Approved Section: 4.55(1A) Application No: SSD-6339-Mod-3
Granted: 7 June 2021 Signed: *[Signature]*
Sheet no: 1 of 19

MODIFICATION APPLICATION

TITLE	
LEVEL 3 - PHASE A (REVISED PLAN)

PROJECT	
RPAC	
26 ALBION STREET WAVERLEY NSW 2024

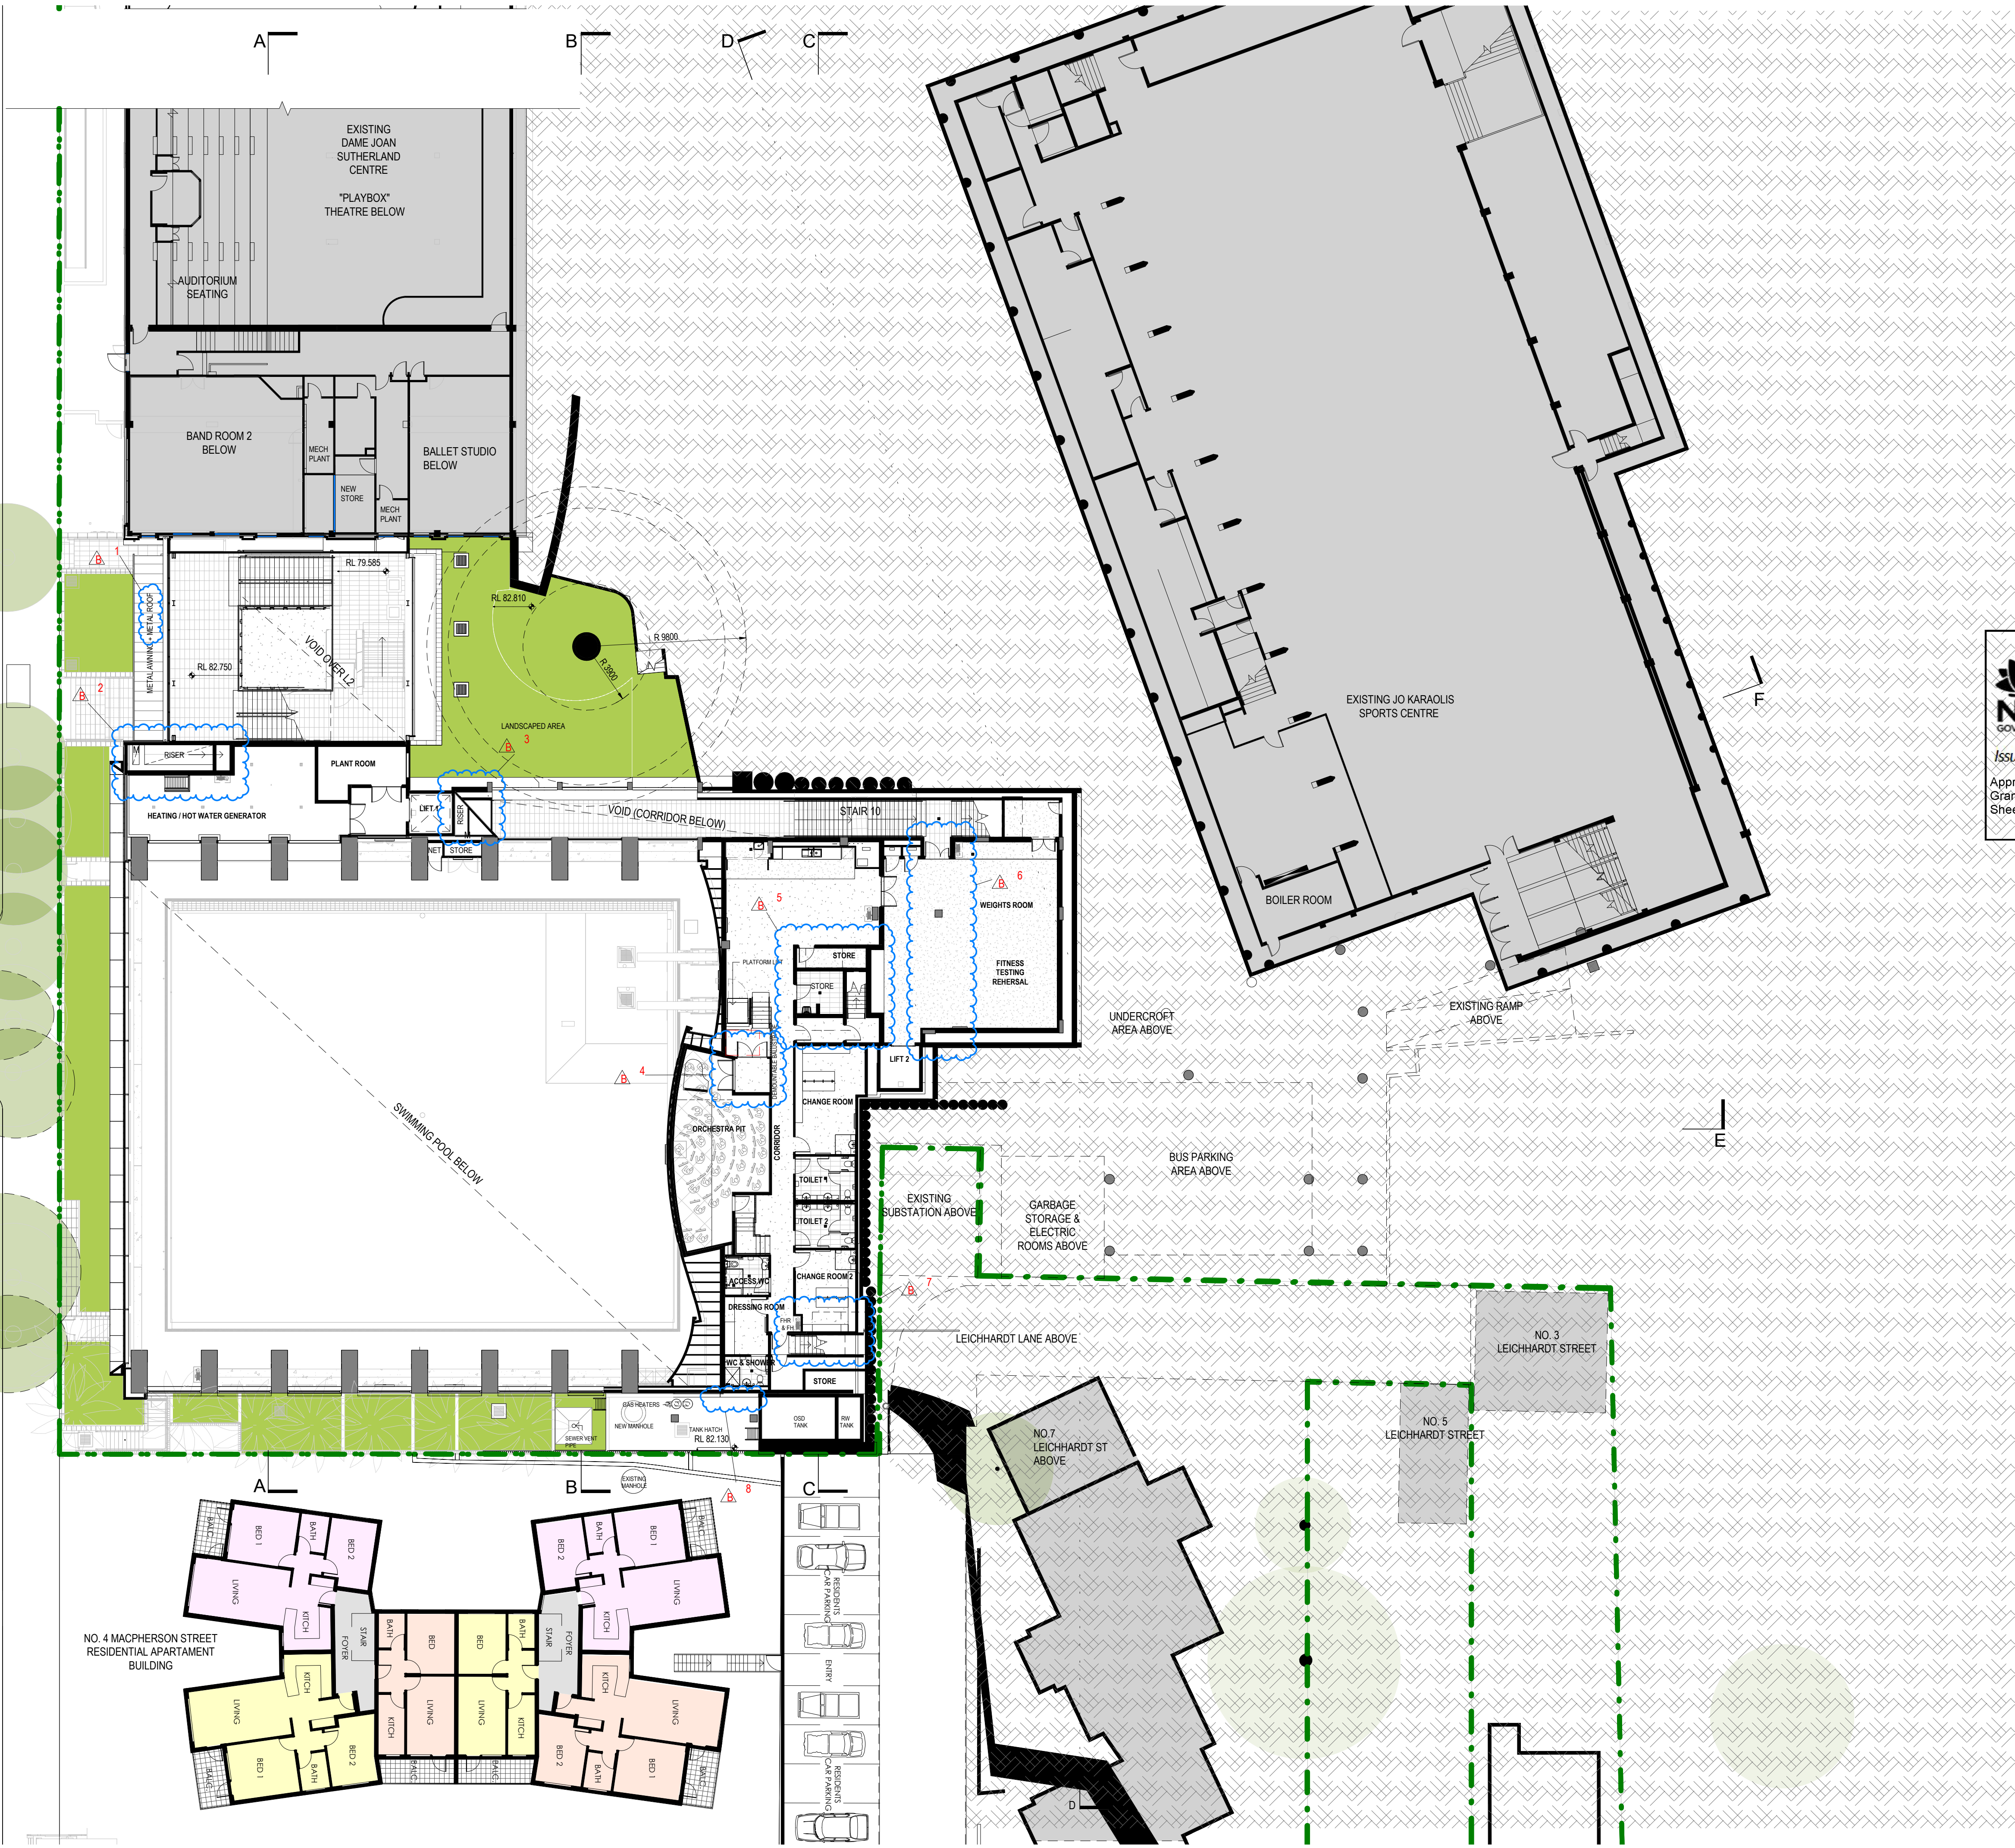
- LIST OF REVISED ITEMS LEVEL 3:
1. METAL AWNING COVER REVISED FROM PEBBLES TO METAL ROOF FOR IMPROVED LONG TERM MAINTENANCE PURPOSES.
 2. SIZE OF SERVICES RISER REVISED FOR SERVICES RETICULATION AND STAIR ORIENTATION AMENDED
 3. SIZE OF SERVICES RISER REVISED FOR SERVICES RETICULATION
 4. NEW AIRLOCK INCLUDED FOR IMPROVED ORCHESTRA PIT FUNCTIONALITY
 5. NEW STAIR TO THE STAGE FOR IMPROVED STAGE FUNCTIONALITY AND AMENDED STORE SPACE LAYOUT.
 6. WEIGHTS/FITNESS ROOM PARTITIONS DELETED AND DOOR RELOCATED FOR IMPROVED SECURITY AND FUNCTIONALITY OF THE ROOM
 7. STAIR ORIENTATION REVISED FOR IMPROVED STAGE FUNCTIONALITY
 8. GREASE ARRESTOR DELETED (NOT REQUIRED)

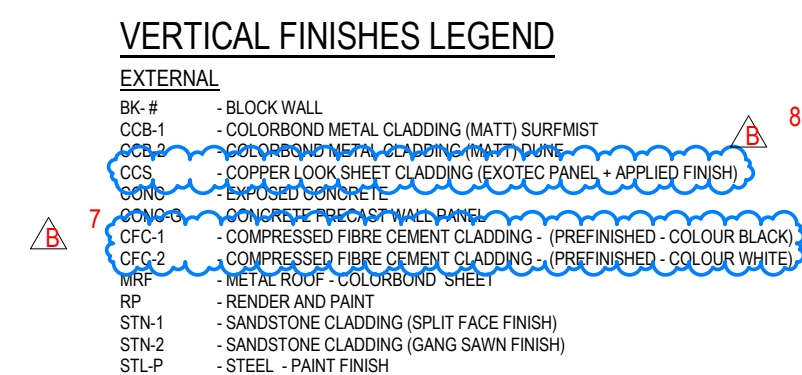
TREES (x2) REMOVED TO ALLOW FOR CONSTRUCTION LOADING ZONE. NEW TREES TO REPLACE THOSE REMOVED AFTER BUILDING COMPLETION.

TITLE
LEVEL 6 - PHASE B (REVISED PLAN)

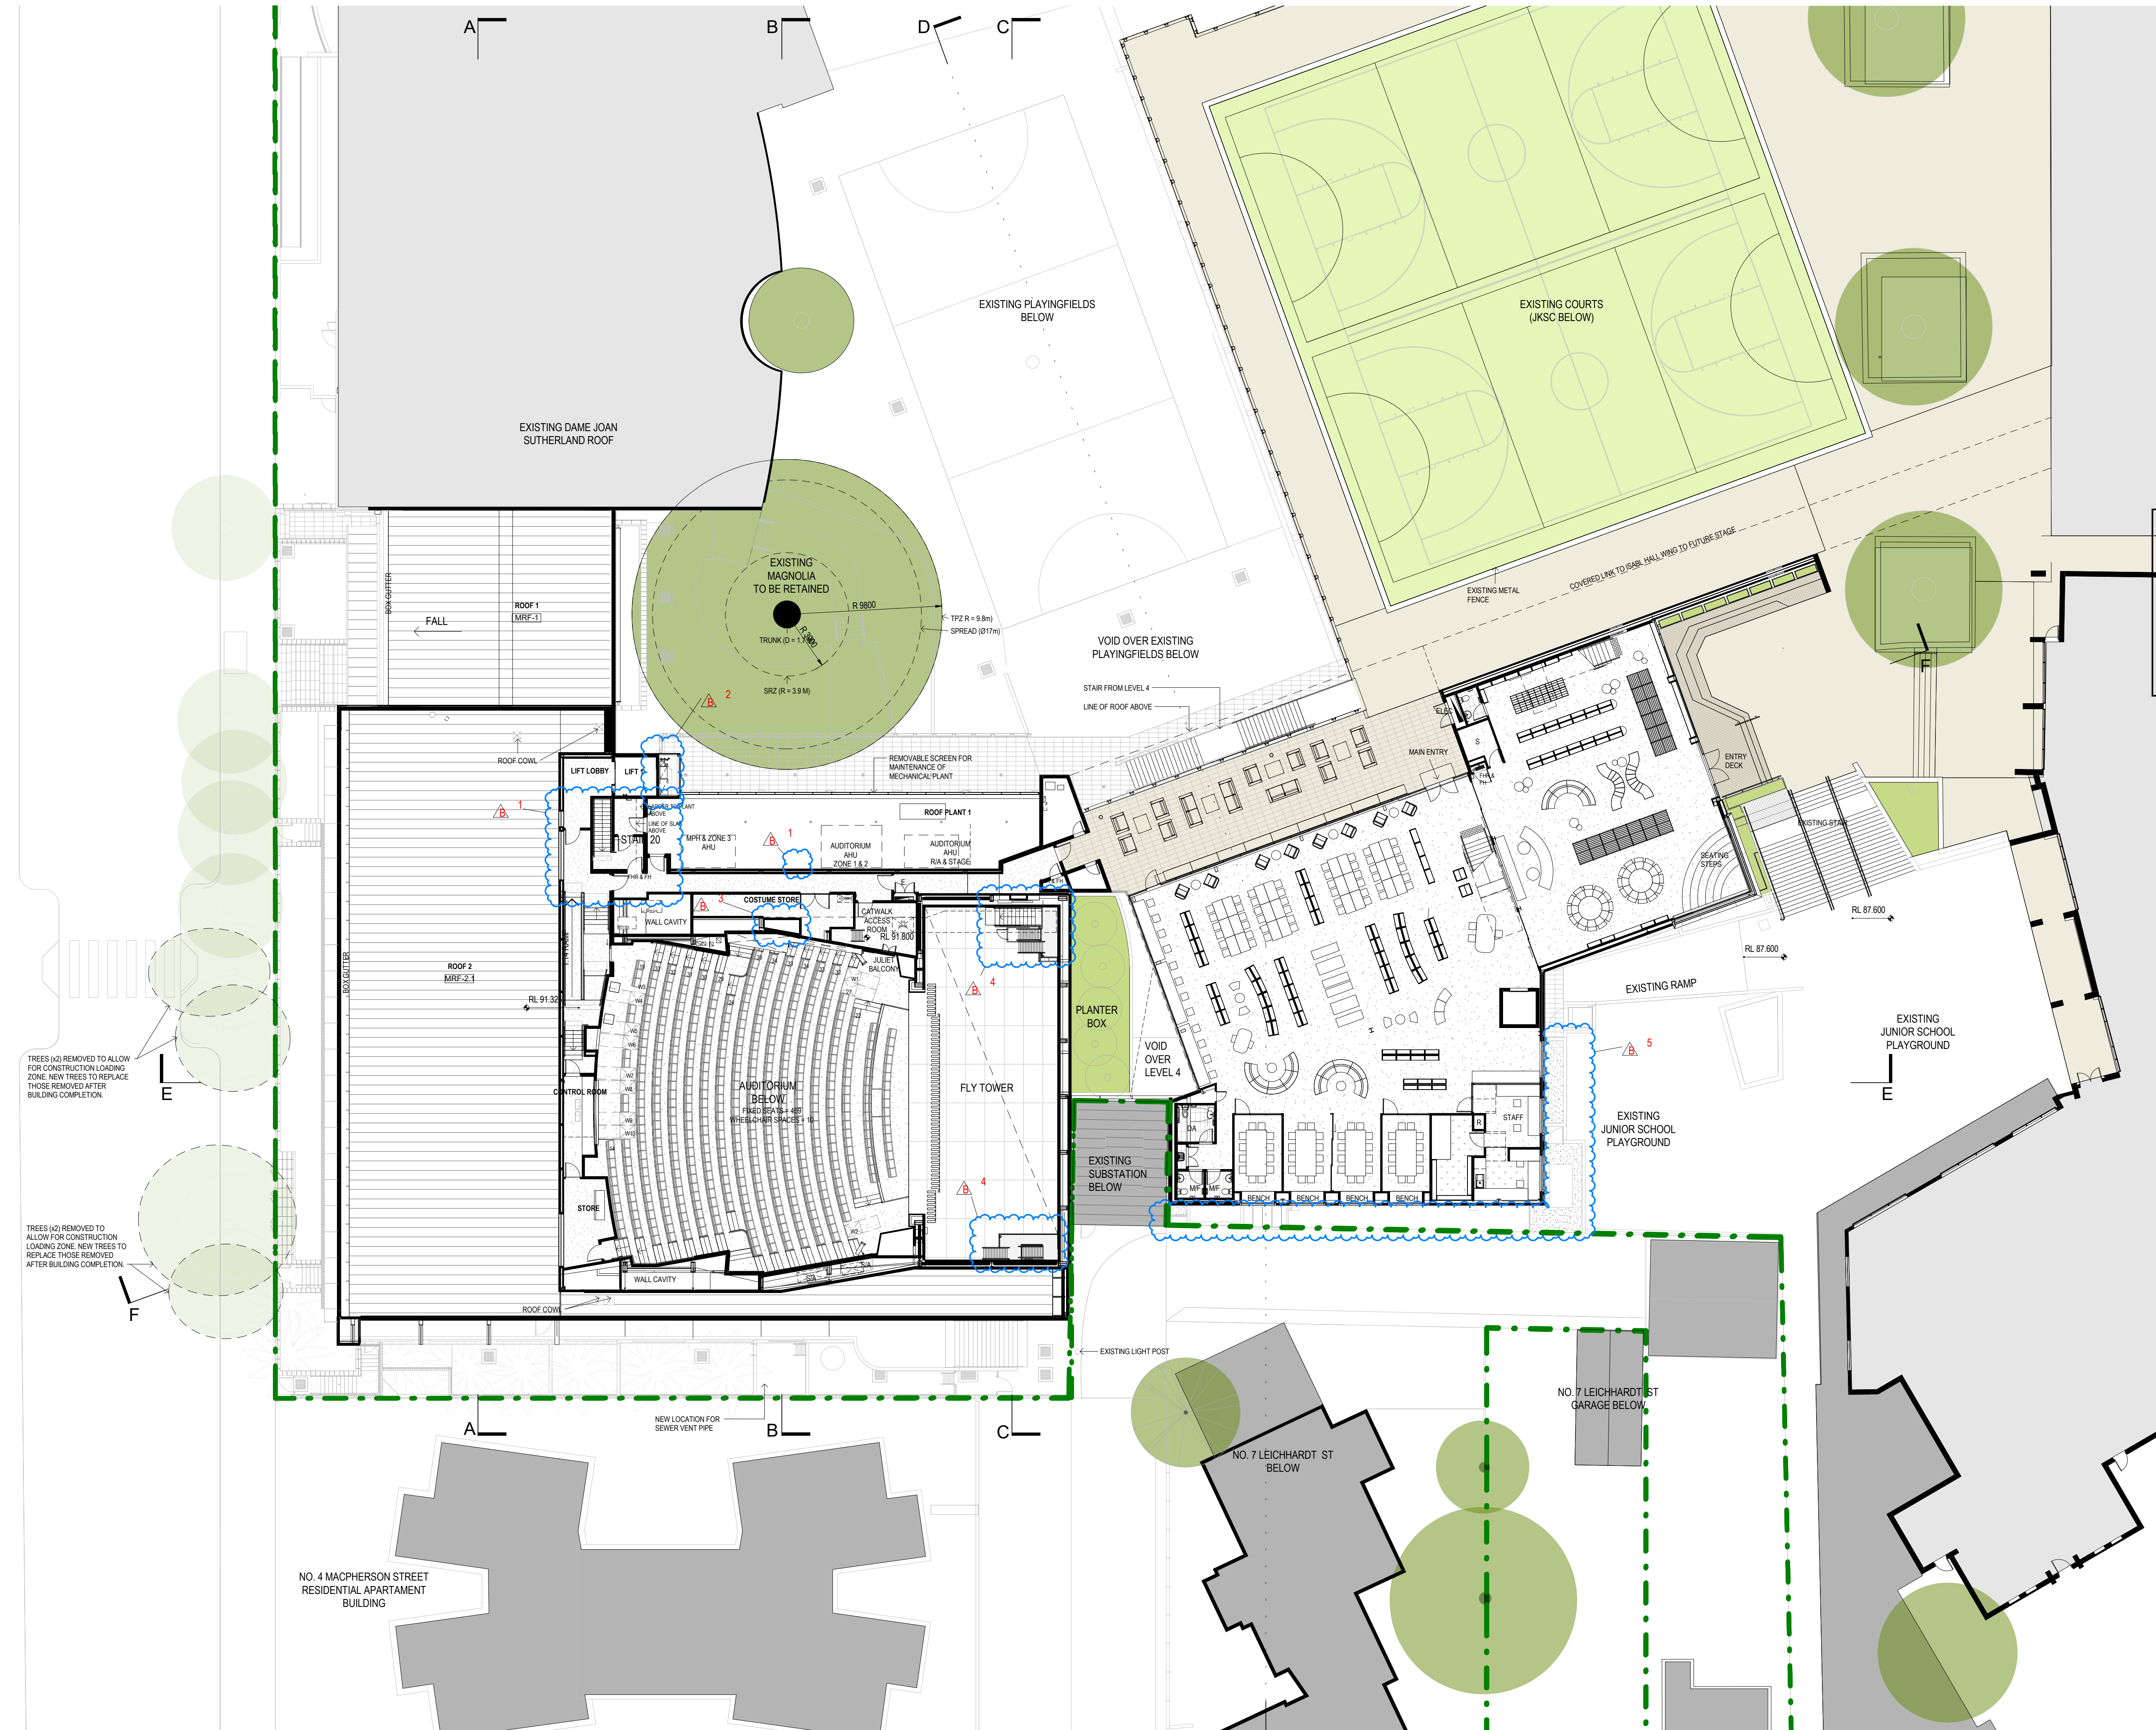
- LIST OF CHANGES LEVEL 6:
1. REVISED DOOR LOCATIONS FOR CORRIDOR AND PLANT AREA FOR FIRE SEPARATION AND EGRESS COMPLIANCE.
 2. REVISED RISER SIZE FOR SERVICES RETICULATION.
 3. NEW MECHANICAL PLENUM INCLUDED FOR SERVICES RETICULATION.
 4. REVISED VERTICAL ACCESS ARRANGEMENT TO STAGE CATWALKS FOR COMPLIANCE AND IMPROVED STAGE OPERATION FUNCTIONALITY.
 5. NEW SUBSTATION LOCATION AND REVISED SERVICE VEHICLE ZONE IN LEVEL 4 (LEVEL BELOW)
